## **APPENDIX A: WCPL'S RESPONSE TO THE COMMISSION'S REVIEW REPORT**

# WILPINJONG EXTENSION PROJECT

## RESPONSE TO PLANNING ASSESSMENT COMMISSION REVIEW

Conceptual Post-mining Topography  
Comparison of EIS and  
Revised Final Landform

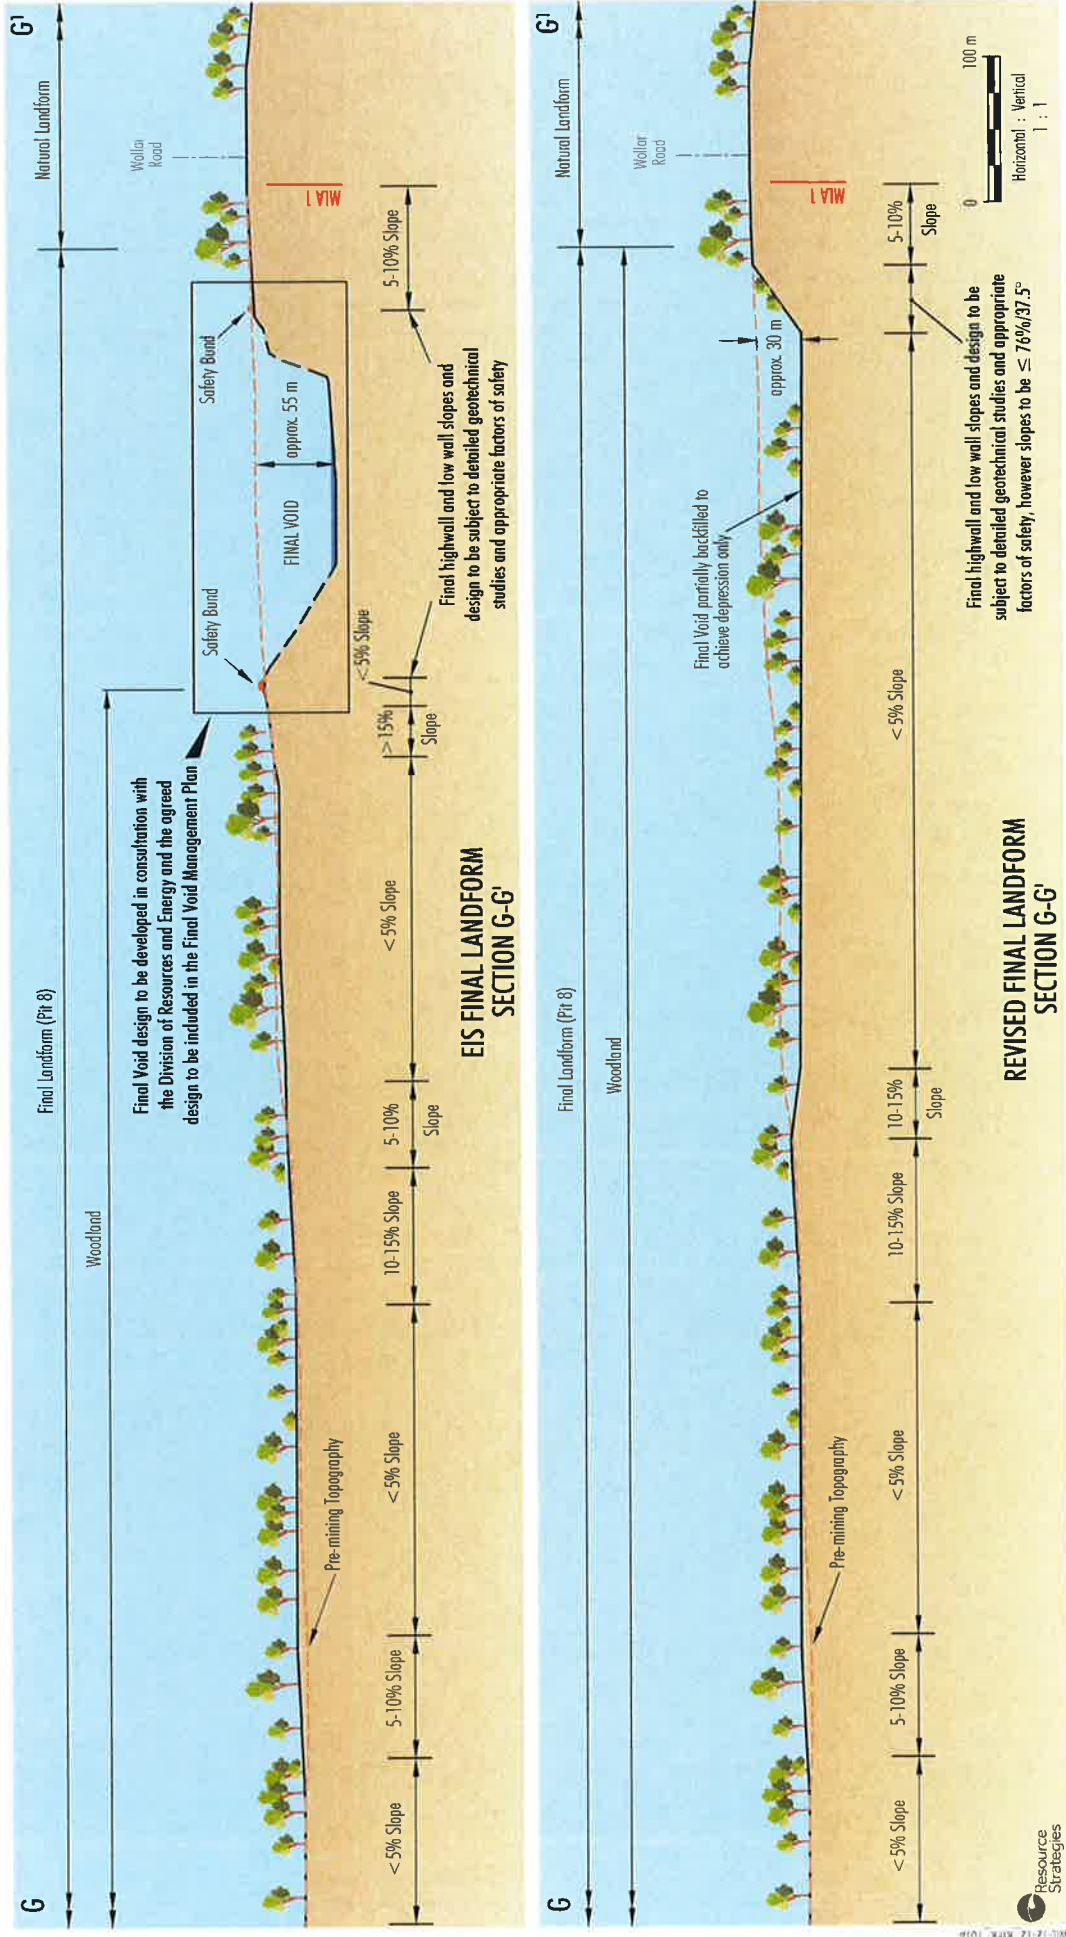
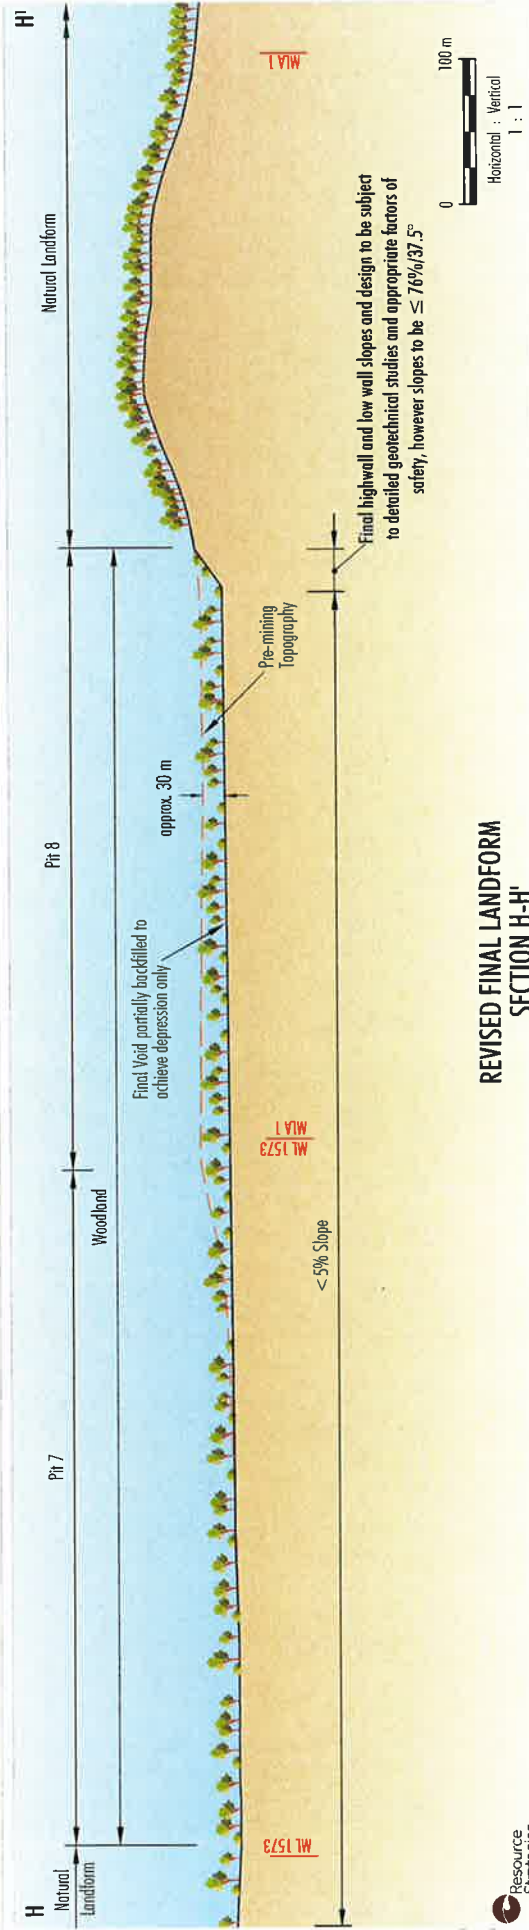
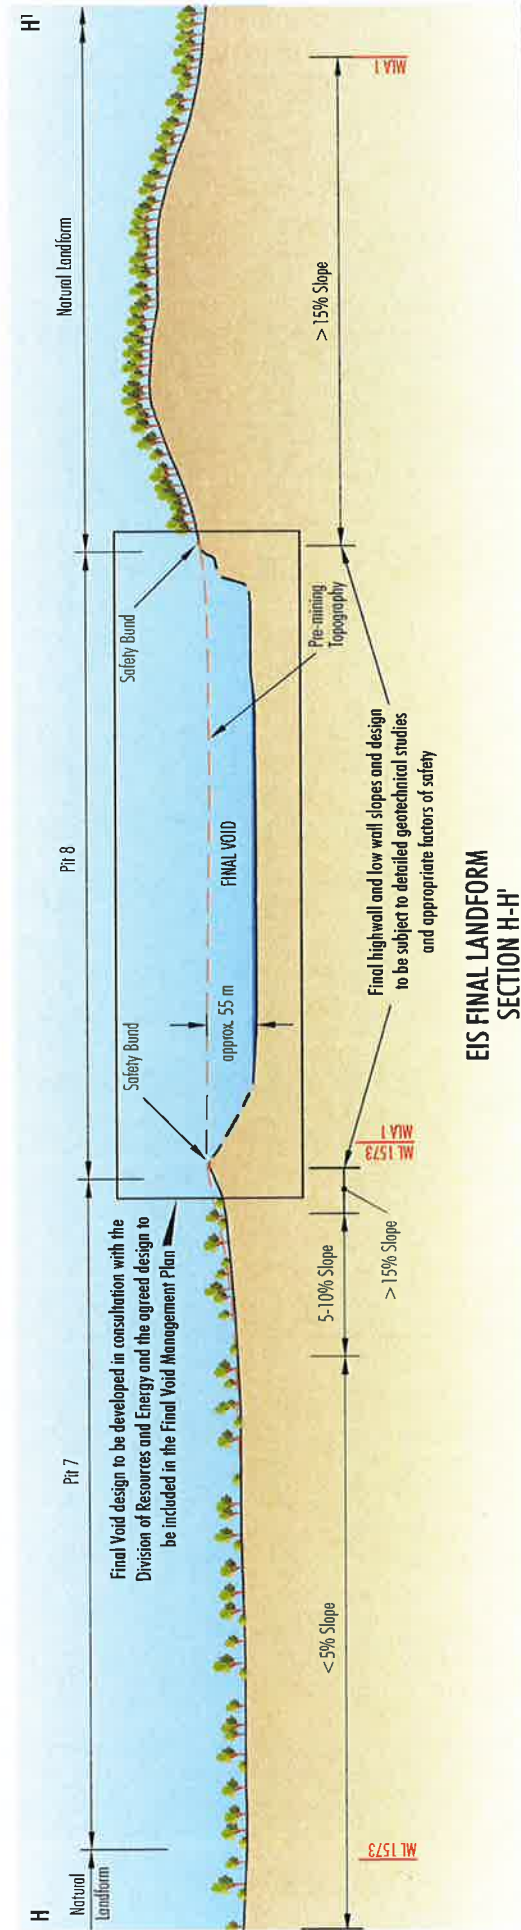
In light of the Project PAC's strong recommendation with respect to the Pit 8 final void, WCPL has considered options to revise the final Pit 8 landform such that the southern end is wholly free draining (either north into Wilpinjong Creek, or west into the Cumbo Valley) and no longer includes a final void.

WCPL's initial investigations suggest that the revised final landform would still be required to include some areas of moderate to steep slopes (i.e. up to approximately 37.5° or 76% slope) at highwall and low wall areas to avoid materially extending the disturbance area of the open cut. However, the revised final landform in this area would predominantly comprise more gentle slopes (i.e. 1% to 15%) and the area that could be rehabilitated to woodland vegetation would be increased.

Figures 1 to 3 illustrate conceptually in both plan and cross section the key differences between the Pit 8 final void as proposed in the EIS and the conceptual revised final landform in the south of Pit 8.

**WILPINJONG EXTENSION PROJECT**  
**Predicted Water Table Drawdown and Interpreted Extent of Unconsolidated Sediments**

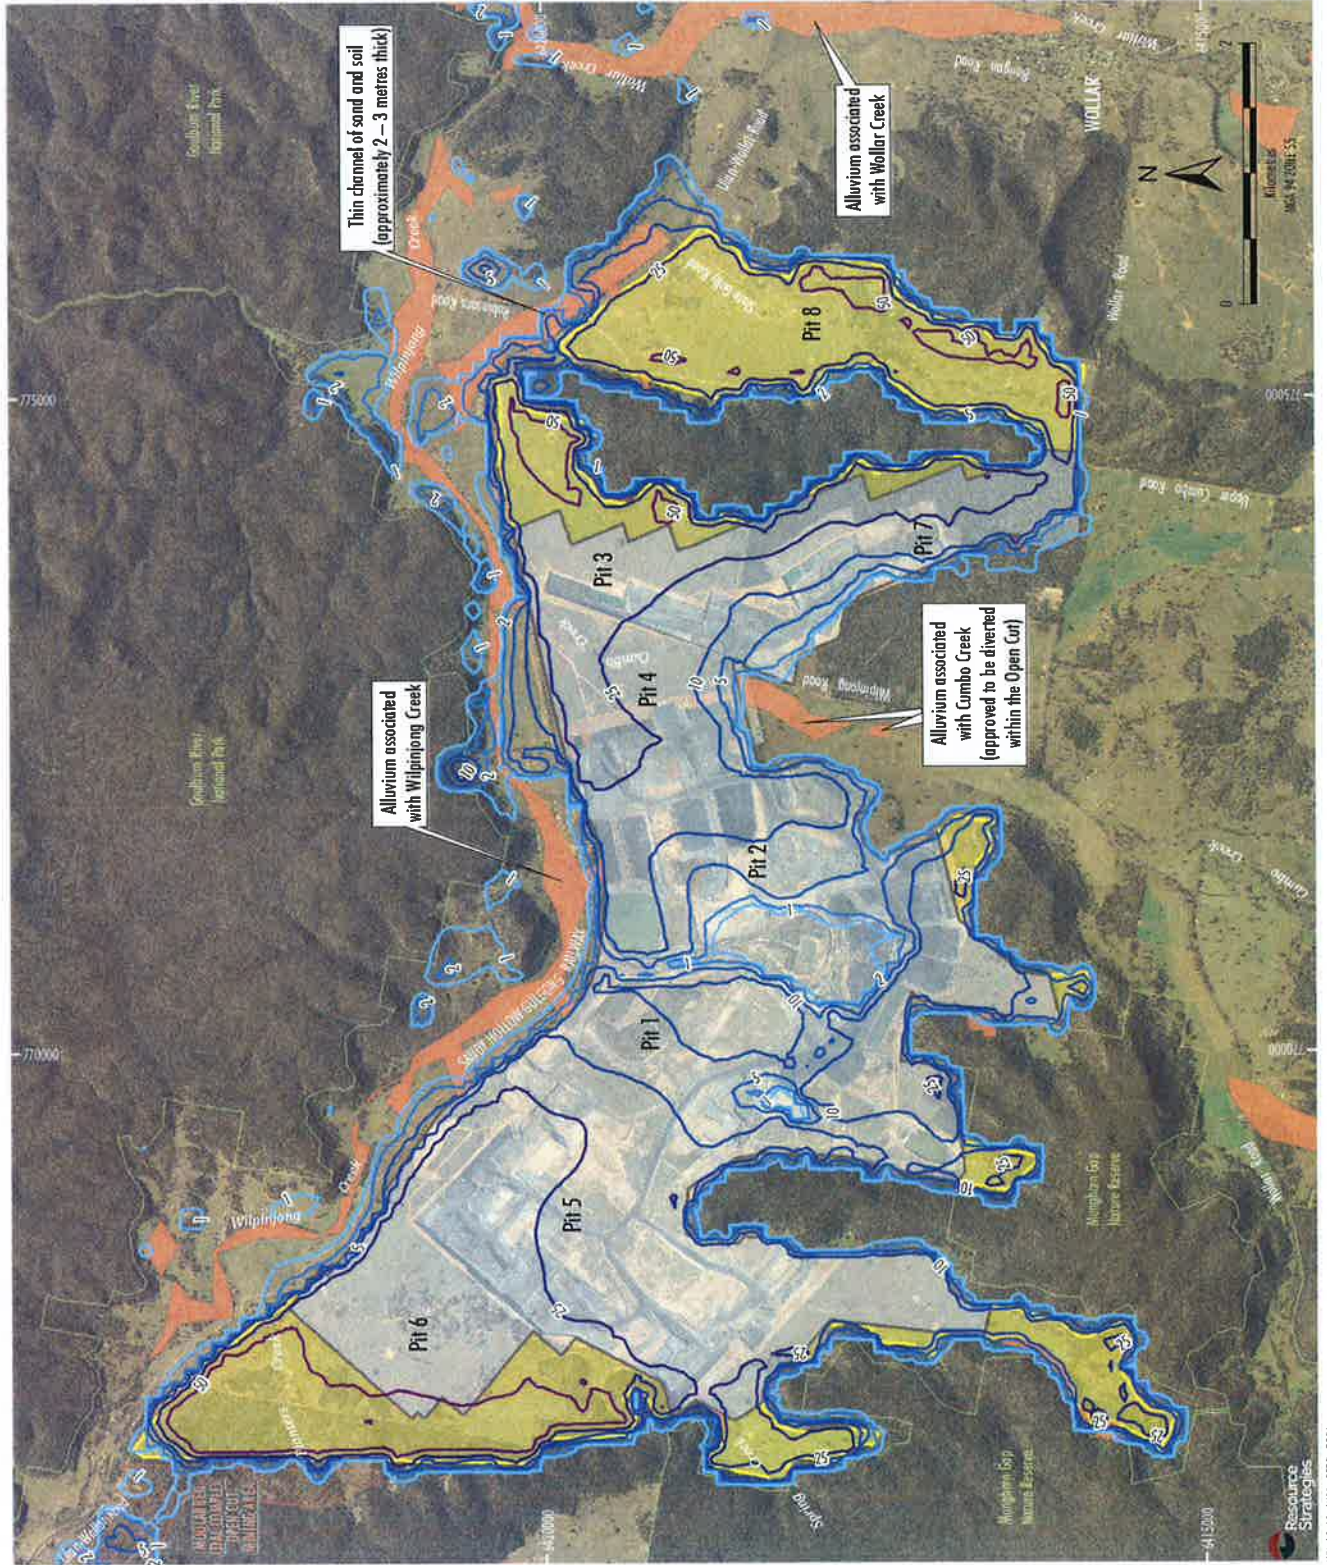
- *the Department is to provide further clarification as to the full extent of drawdown on the alluvial aquifers within and around the project site to enable a full assessment of the predicted impacts;*

The interpreted extent of unconsolidated sediments outside the open cut and contained infrastructure areas is shown on Figure 4. Alluvial deposits are associated with Wilpinjong and Cumbo Creeks in the vicinity of the Wilpinjong Coal Mine, and along Wollar Creek to the east of Pit 8 (HydroSimulations, 2015). Exploration bores to the north of Pit 8 also indicate the presence of a few metres of sand or soil (HydroSimulations, 2015).

The predicted water table drawdown due to the Wilpinjong Coal Mine incorporating the Project and the interpreted extent of unconsolidated sediments are shown on Figure 4. Minimal drawdown (approximately 1 m) is predicted in the aquifers of the shallow alluvial groundwater system along Wilpinjong Creek and less around Wollar Creek.
